Subject: P.H.O. APPLICATION NO. PHO-12-25--Z-204-87-1 – Notice of Pending Actions by the **Planning Hearing Officer**

APPLICATION NO: PHO-12-25--Z-204-87-1

Request For: Stipulation Modification

RE: Planning Hearing Officer – Application for Stipulation Modification to PHO-6-97-Z-204-87; 20637 N. 27th Avenue (APN 209-08-027) & 20627 N. 26th Avenue (209-08-09E)

PRELIMINARY SITE PLAN

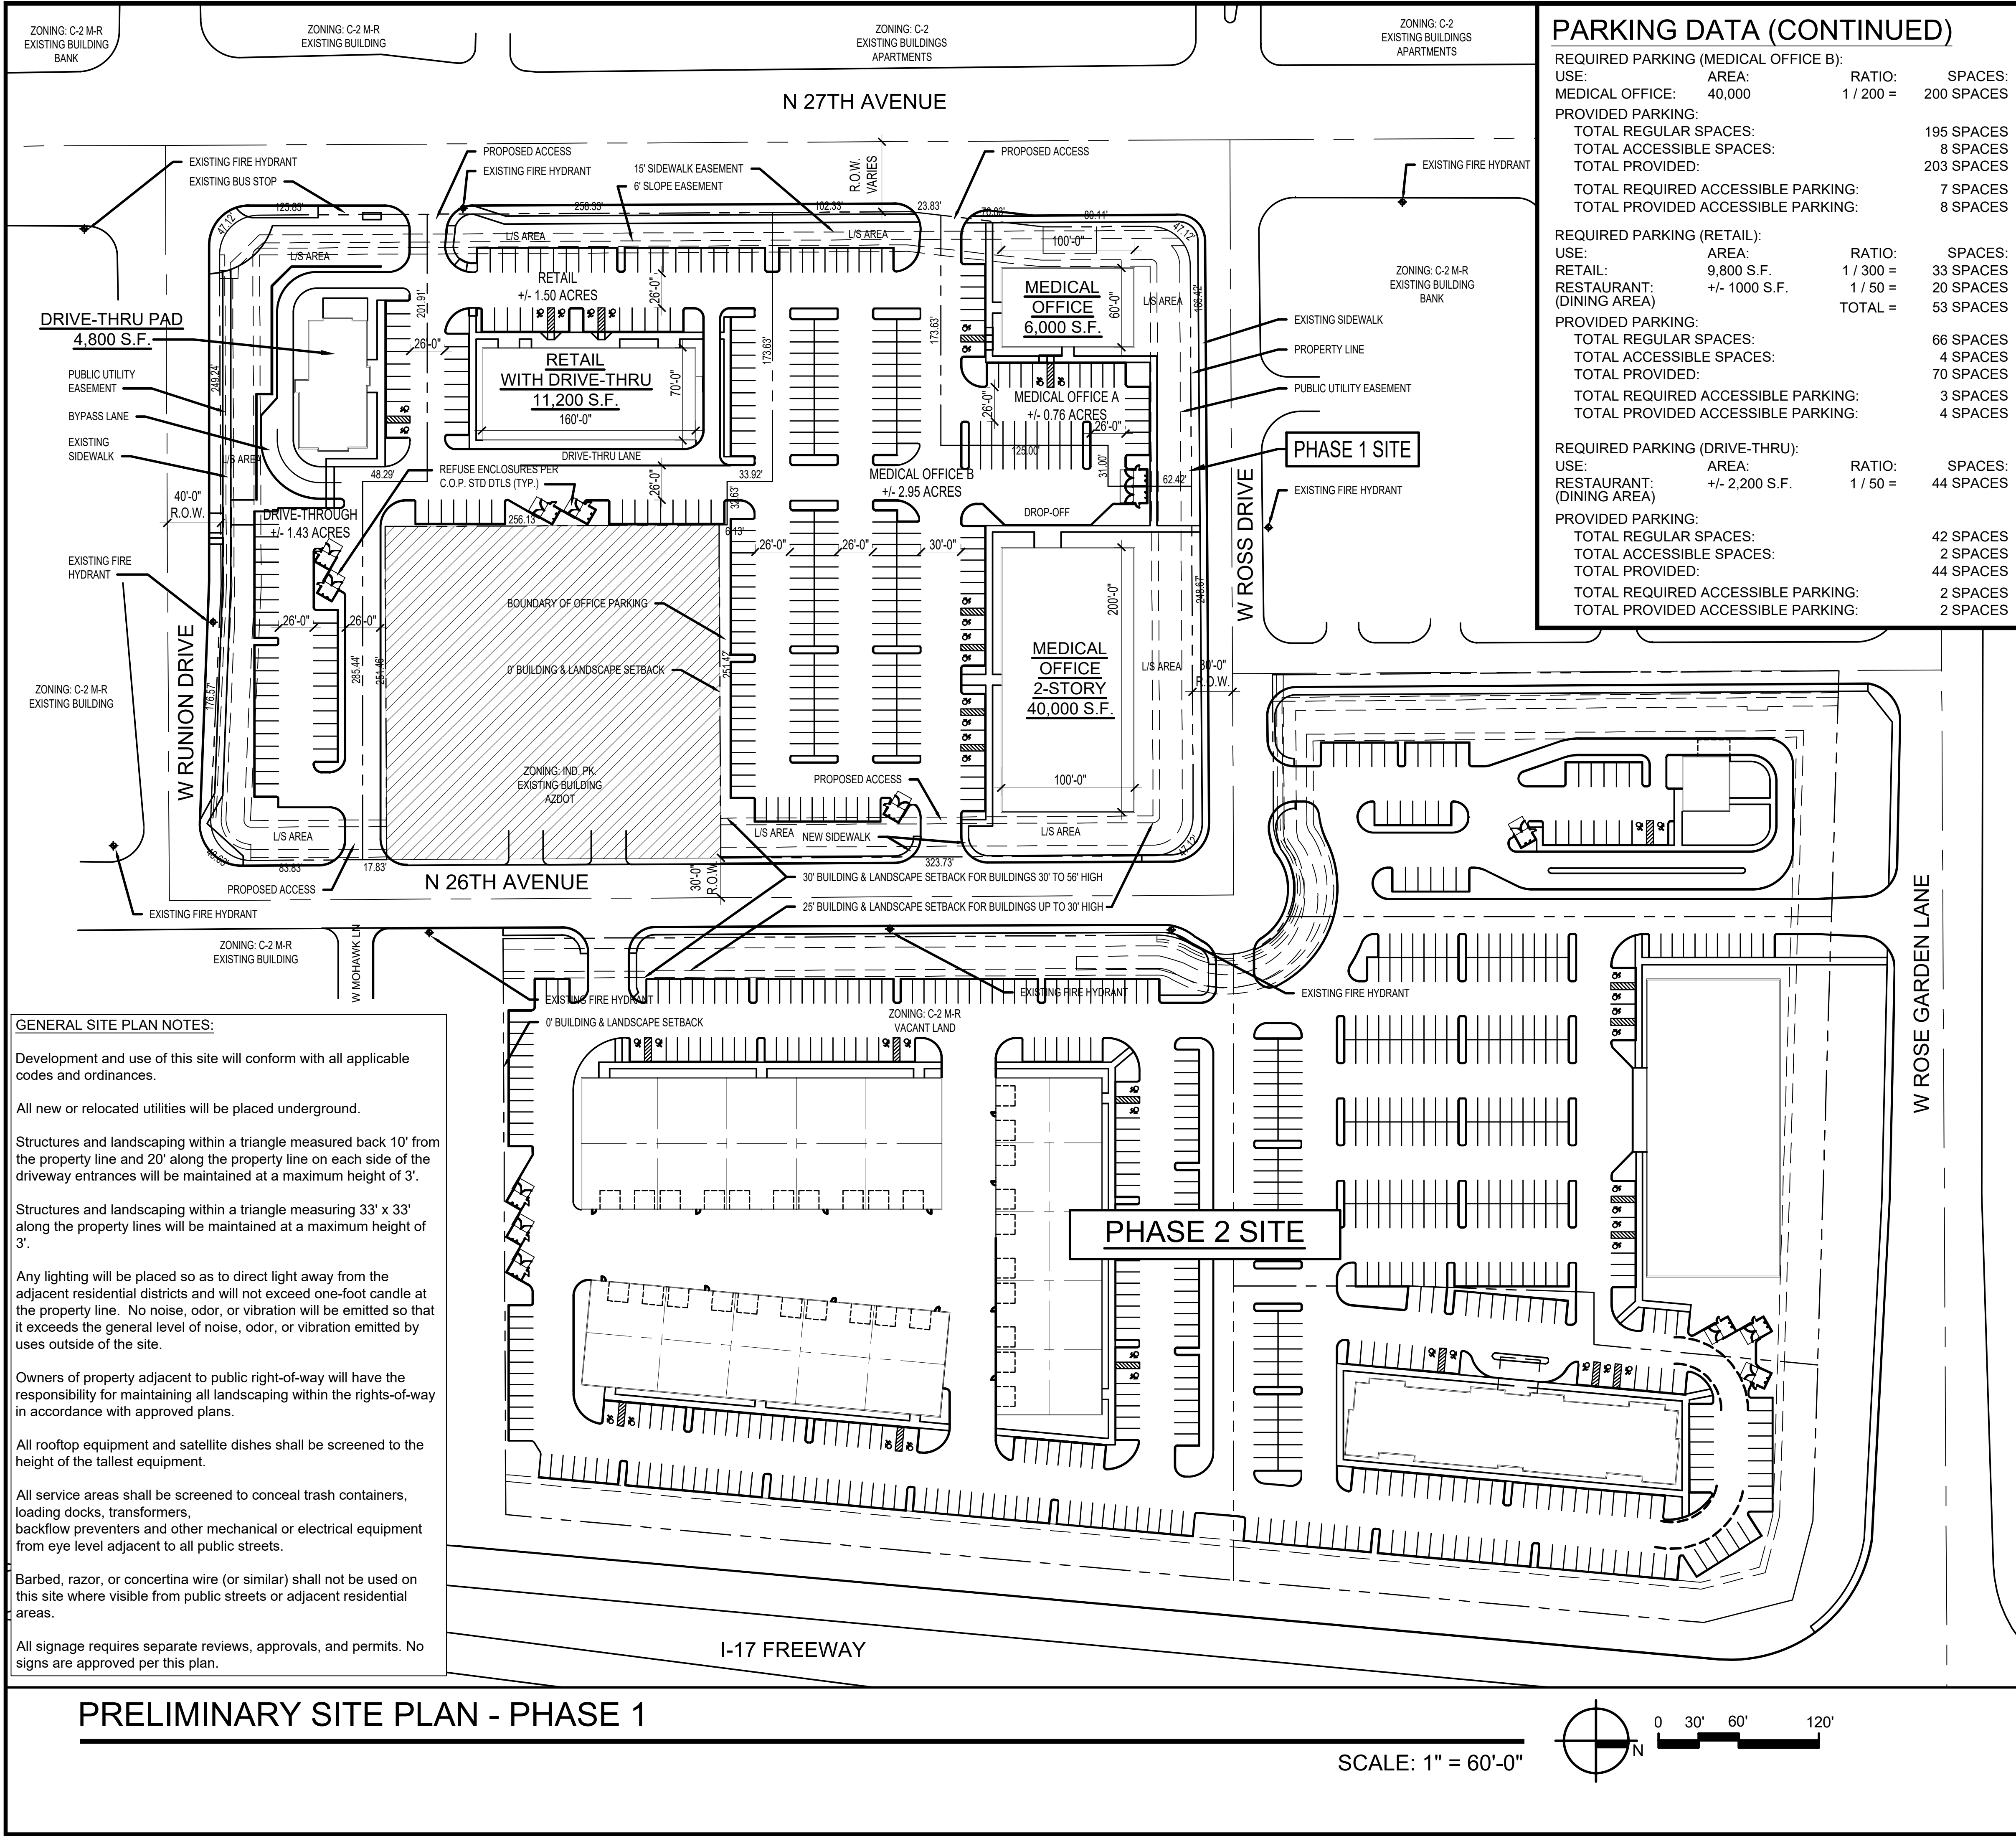
1. That development be in general conformance to the site plan presented at the Planning Hearing Officer hearing of April 2, 1997 and design guidelines dated February 14, 1997 as may be modified by the following stipulations or in the alternative, the applicant may utilize the approved site plan dated September 12, 1996 for retail development on the east side of 27th Avenue. Notwithstanding the following stipulations, APN 209-08-027 and APN 209-08-029E may be developed in general conformance with the approved plan dated ***, 2025.

Applicant Reasoning: The proposed plan for The Interchange encompasses both APN 209-08-027 and 209-08-029E and imagines a variety of uses such as medical office, flex office, retail, drive thru and hotel. The Interchange conforms with the needs of the current market, particularly in the corridor of the Deer Valley Village, which severely lacks new ground-up development opportunities providing for these uses.

The currently approved plan overlaying APN 209-08-027 and 209-08-029E contemplates an outdated plan. The plan for The Interchange contemplates a proposed 130 room extended stay-type hotel for an area that has experienced exceptional growth since the approval of the current plan. The Interchange will also include upwards of 90,000 square feet of medical uses to provide relief to an area of the City in desperate need of medical use opportunities. Further, additional retail options for the local business community and residents will provide a tangible benefit to the area.
